This meeting of the Grimes Planning and Zoning Commission was called to order Tuesday January 7, 2020 at 5:30 P.M. at Grimes City Hall.

The Development Services Department is in receipt of a proposed Site Plan for Destination Market Plat 4. Based on the review of the provided submittal materials, staff have the following comments:

Planning & Zoning Staff Report

The Development Services Department is in receipt of a proposed Site Plan for KinderCare. Based on the review of the provided submittal materials, staff have the following comments:

DESTINATION MARKET PLAT 4
DIMENSION & GRADING PLAN
GRIMES, IOWA

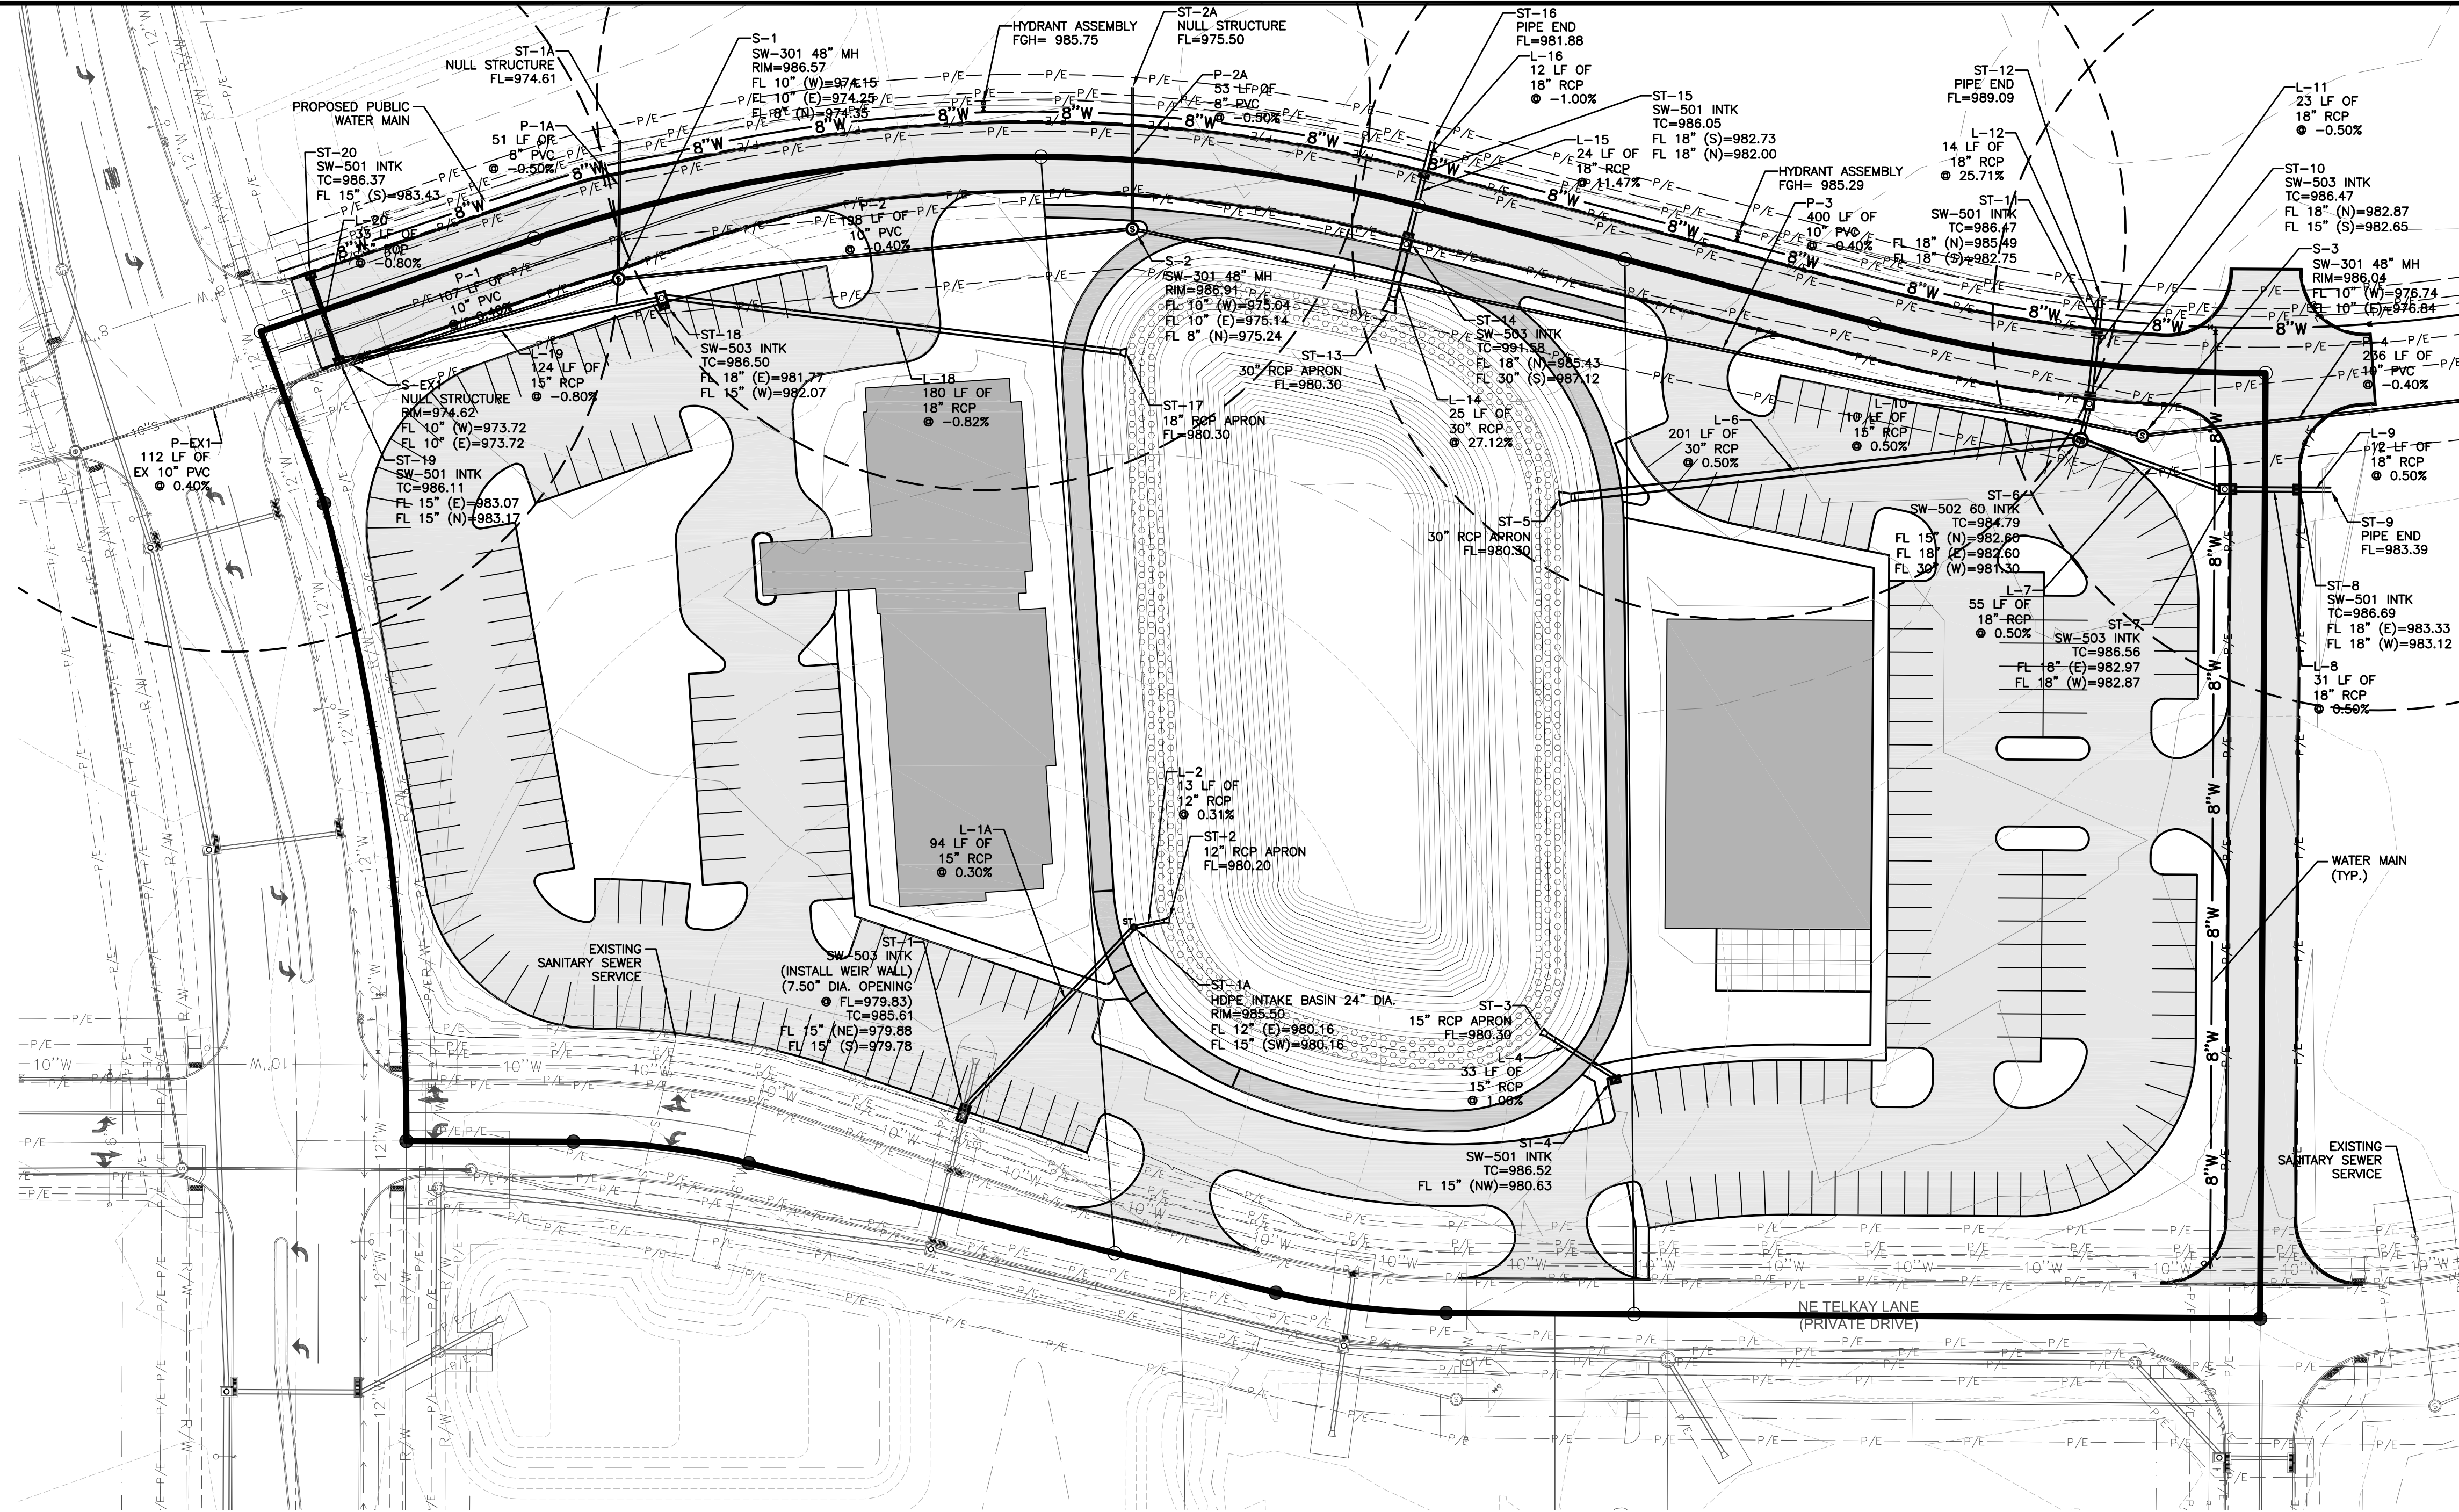
- ~~4. Please show all proposed streets, utilities, grading, easements, etc.~~
- ~~5. Staff questions if the owner intends to stock the pond. If so, please refer to updated IDNR standards for urban fishing.~~
6. Please darken the property lines.
7. Please provide ingress/egress easements over the site and common areas.

UTILITY PLAN

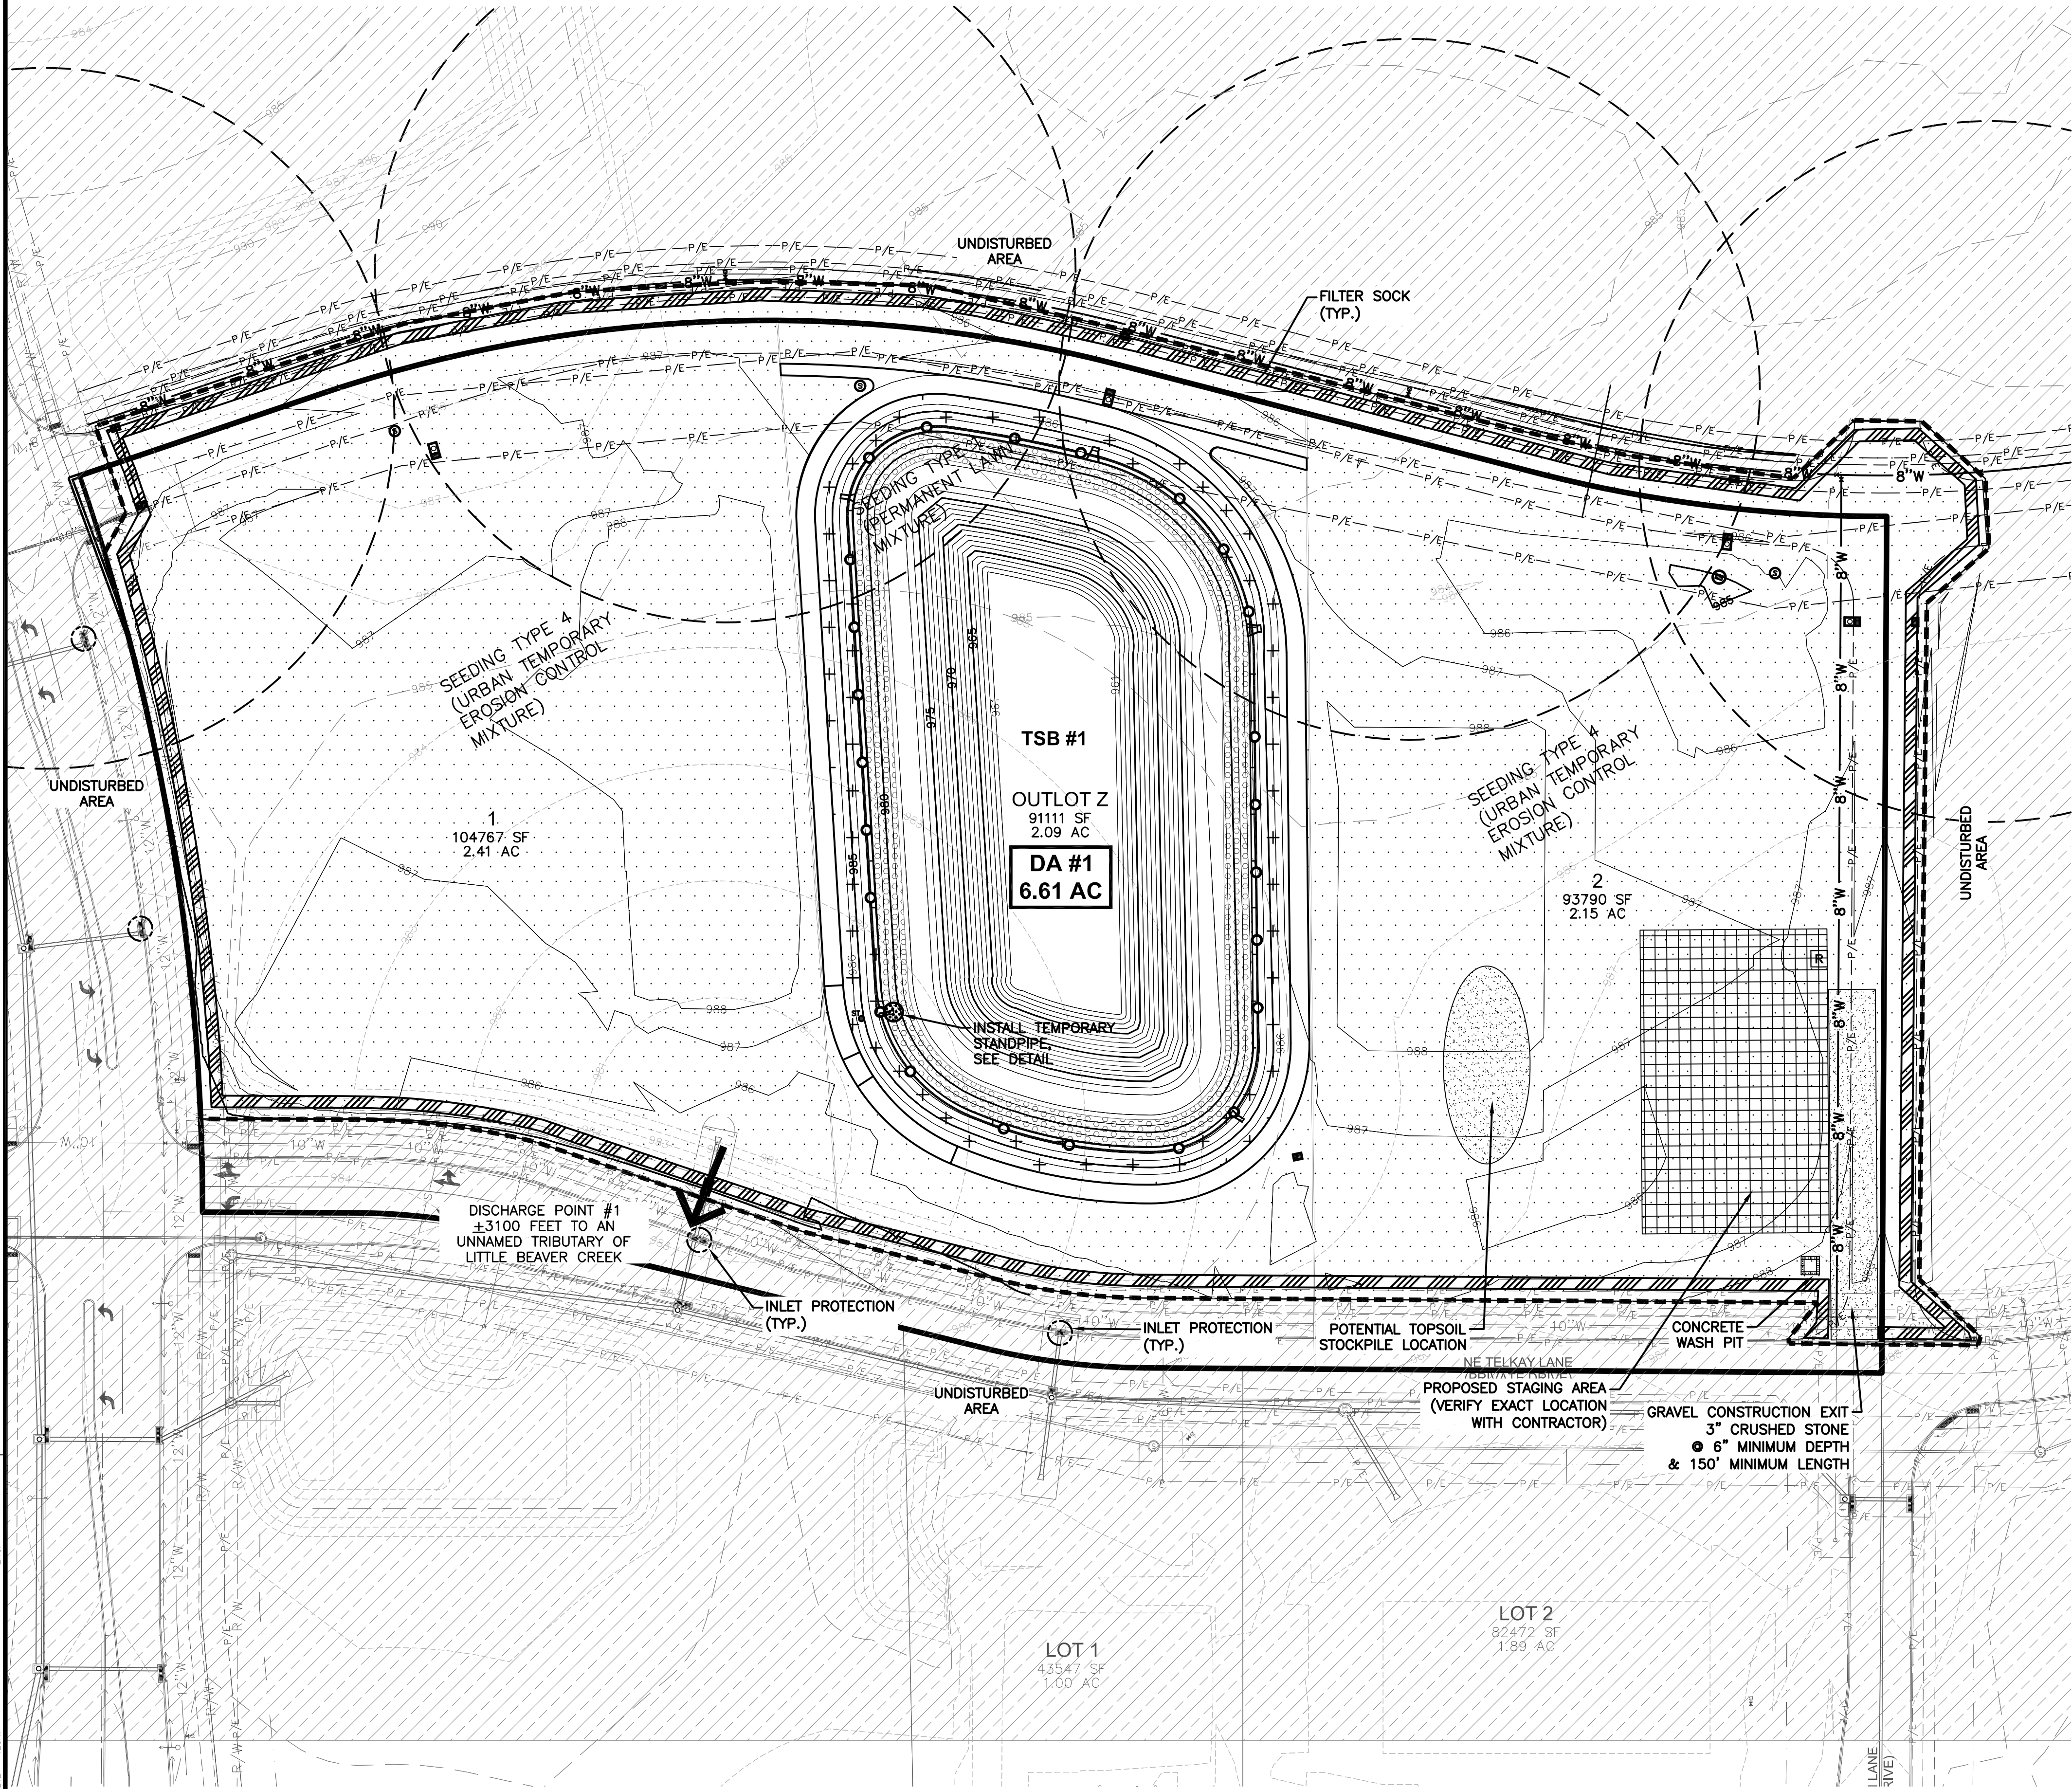
8. Please show the construction entrance
9. Please show the staging area
10. Please show the PCC washout station
11. Please indicate seeding types.
12. Please indicate if the temporary standpipe has an open or closed top
